# Comments and Responses Report: Public Participation on Draft Scoping Report Proposed Granger Bay Precinct Development at the V&A Waterfront

DEA&DP REF: 16/3/3/2/A7/4/3051/25

**DATE:** 15 January 2026

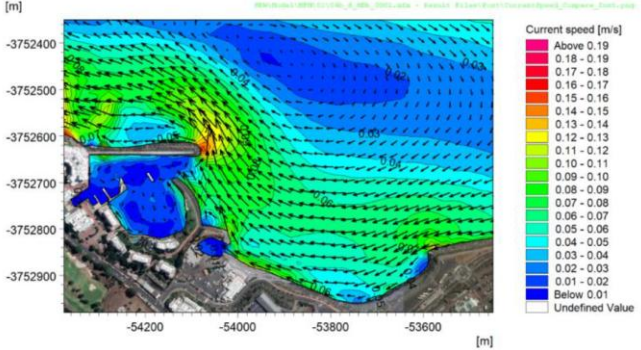
Date	Method	Name	Interest	Comment / Query	Response
				<p>This response is submitted on behalf of the Waterclub Berthholders Association (BHA), which manages and operates the Waterclub Marina. The marina lies within 200 metres of the planned V&amp;A development and comprises three major jetties, associated walkways, electrical and water services, and 74 privately owned moorings.</p> <p>It appears that no notice has been given to berth owners—whether residents or third-party owners—whose property rights and asset values stand to be affected.</p>	<p>EIA Report, where relevant and appropriate.</p> <p>The submission of comments on behalf of the Berthholders Association is noted. There are no public records that indicate that the Marina is operated by a separate entity to the Waterclub itself, nor that any moorings may be registered as owned separately from the Waterclub itself – thank you for bringing this to our attention. In earlier engagements with Ms Ponton the impression had been given that the management of the Water Club Association had undertaken to notify all owners on behalf of the EAP, since the sharing of contact information for individual owners was not consistent with the provisions of the Protection of Personal Information Act, 2013. We also note that on 11 August 2025, we received email confirmation from Ms Ponton that the notification of the pre-application public participation process had been 'immediately forwarded to all registered owners'. Media and site notices, together with significant public media attention to the public participation process, will have aided in drawing the attention of all potential interested and affected parties to the opportunity to comment and register as I&amp;APs.</p>

<p><b>2. Overview</b></p> <p>Separate and apart from the defective notice issue, the Draft Scoping Report suffers from a fundamental evidentiary gap:</p> <ul style="list-style-type: none"> <li>• No bathymetric study of the marina appears to have been undertaken; and</li> <li>• No request was made to the BHA to supply its historic bathymetric records.</li> </ul> <p>No explanation is provided for these omissions.</p>	<p>The PRDW Wave and Hydrodynamic Modelling Report (Appendix G to the Scoping Report) includes a bathymetric survey for the model</p>

Date	Method	Name	Interest	Comment / Query	Response
					<p>The submission of these comments by (or on behalf of) the Berthholders Association is an indication that the Association itself is at least informed of the public participation process.</p> <p>The EAP undertakes to ensure that all I&amp;APs have a reasonable opportunity to participate, and to this end any potential I&amp;AP is invited to register their interest at any time, using the project website, WhatsApp number, or email address.</p> <p>Furthermore, media and site notices and additional notifications to potential I&amp;APs who have not yet registered their interest, will be distributed at the commencement of public participation on the draft EIA Report. The management of the Water Club Association will also again be approached for assistance either in providing contact details for individual berth holders, or distributing notifications internally.</p>
